Incorrect Installation Manual Instruction

Product: ProCore® Processor

April 25, 2008

ProCore Tow Hitch Kit

Figure 6

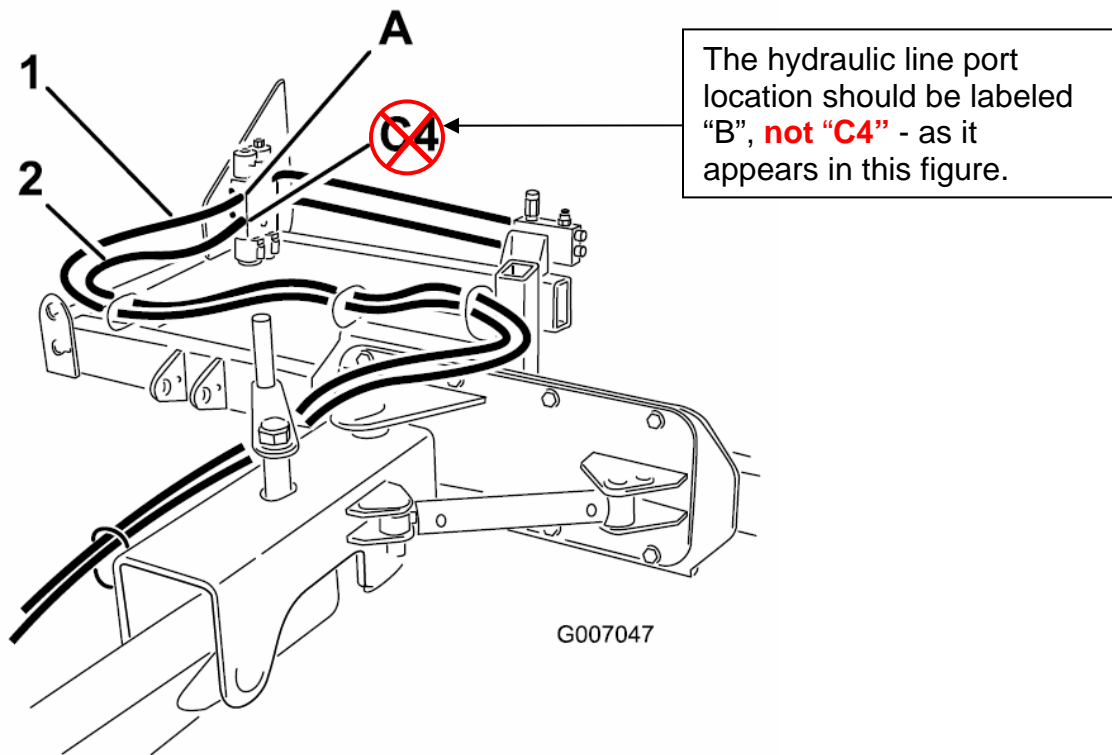
There are errors in the installation instruction manual regarding hydraulic plumbing between the tow vehicle and the Tow Hitch Kit Manifold-HYD (114-7729). The schematic in this manual contains hydraulic port label errors and omits the presence of a check valve in the Core Processor Lift Manifold Block Assembly (114-3942).

Figure 6 of the installation instruction, page 2 with correction illustrated:

Figure 7

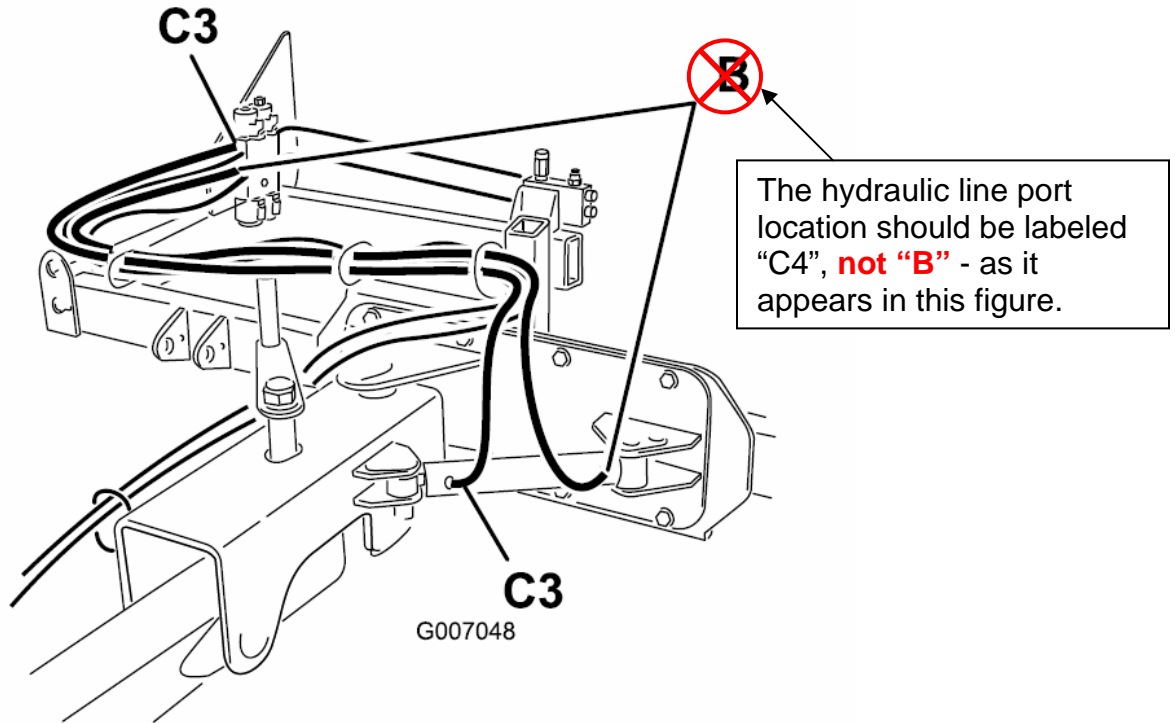
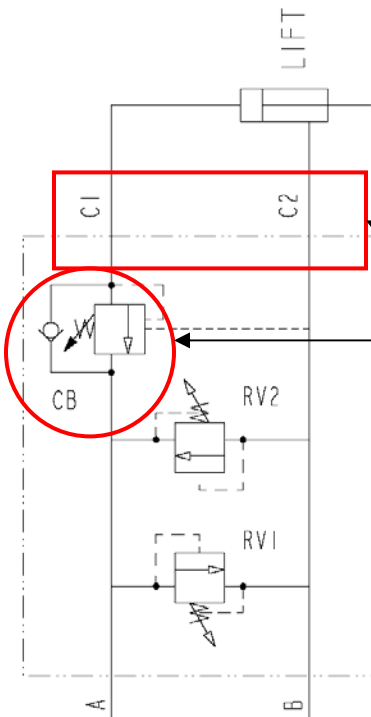
Figure 7 of the installation instruction, page 2 with the correction illustrated:

The indicated items did not previously appear in this diagram;

1. C1 and C2 ports to the lift cylinder were incorrectly labeled "2" and "1" in the Operator's Manual schematic
2. The check valve "CB" was not previously illustrated. This check valve is used to hold hydraulic pressure in the system to support the Core Processor on the transport wheels when disconnected from a tow vehicle and to allow easy, non-pressurized removal of the "quick disconnect" hydraulic connectors.

This is the correct Hydraulic Schematic drawing for the Tow Hitch Kit.
